**SUBDIVISION REVIEW SHEET****CASE NO.:** C8J-2008.0168.01.6A**PC DATE:** 7/12/2022**SUBDIVISION NAME:** Entrada Phase 2 A Small Lot Subdivision**AREA:** 24.56 acres**LOT(S):** 139**OWNER/APPLICANT:** AG Essential Housing Multi State 2, LLC. (Steven Benson)**AGENT:** Carlson, Brigrance & Doering, Inc. (Brendan McEntee)**ADDRESS OF SUBDIVISION:** Entrada Tranquila Way**GRIDS:** Q-34, Q-35**COUNTY:** Travis**WATERSHED:** Gilleland Creek**JURISDICTION:** 2-Mile  
ETJ**EXISTING ZONING:** N/A**MUD:** N/A**PROPOSED LAND USE:** Single Family**ADMINISTRATIVE WAIVERS:** N/A**VARIANCES:** None**SIDEWALKS:** Sidewalks will be provided on all internal streets.**DEPARTMENT COMMENTS:** The request is for approval with conditions of Entrada Phase 2 A Small Lot Subdivision consisting of 139 lots on 24.56 acres. Water and wastewater will be provided by the City of Austin.**STAFF RECOMMENDATION:** Staff recommends approval of the plat, subject to the conditions listed in the attached comment report. After the conditions are met, the plat will comply with City of Austin Land Development Code, Chapter 30-2-84(B). The conditions include plat note revisions, payment of parkland fees and a water quality

LOCATION MAP  
N.T.S.

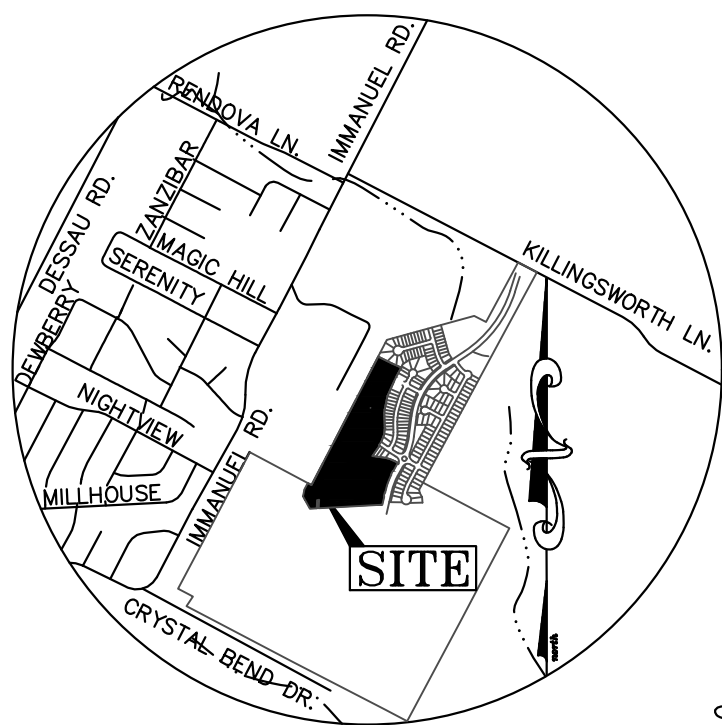
AD4: Please remove the punctuation marks in CRYSTAL BEND DR on the location map

AD5: Please remove the punctuation marks in DESSAU RD on the location map

AD6: Please remove the punctuation marks in RENDOVA LN on the location map

AD7: Please remove the punctuation marks in KILLINGSWORTH LN on the location map

AD8: Please remove the punctuation marks in IMMANUEL RD on the location map

AD9: **ZANZIBAR LN** is the correct name for this project on the location map. The street type is missing. Please update as seen here.

AD10: **MAGIC HILL DR** is the correct name for this project on the location map. The street type is missing. Please update as seen here.

AD11: **SERENITY DR** is the correct name for this project on the location map. The street type is missing. Please update as seen here.

AD12: **DEWBERRY DR** is the correct name for this project on the location map. The street type is missing. Please update as seen here.

AD12: **NIGHTVIEW DR** is the correct name for this project on the location map. The street type is missing. Please update as seen here.

AD12: **MILLHOUSE DR** is the correct name for this project on the location map. The street type is missing. Please update as seen here.

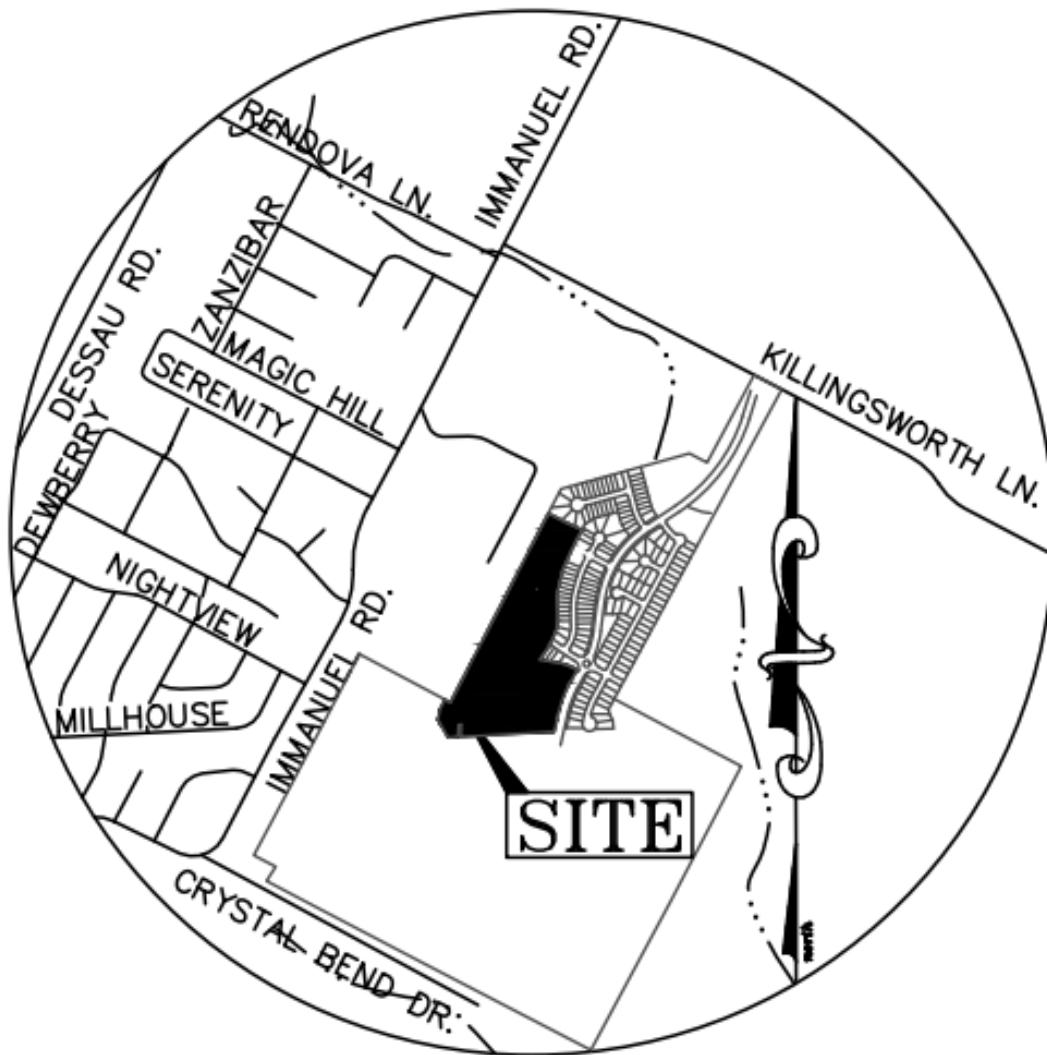
- EL 1.** Note 22 on page 5 shows a 10' PUE is being dedicated adjacent to all streets. Please show this 10' PUE on the face of the Plat as well.
- EL 2.** Please replace note 11 on page 5 with this note "Austin Energy has the right to prune and/or remove trees, shrubbery and other obstructions to the extent necessary to keep the easements clear. Austin Energy will perform all tree work in compliance with Chapter 25-8, Subchapter B of the City of Austin Land Development Code."
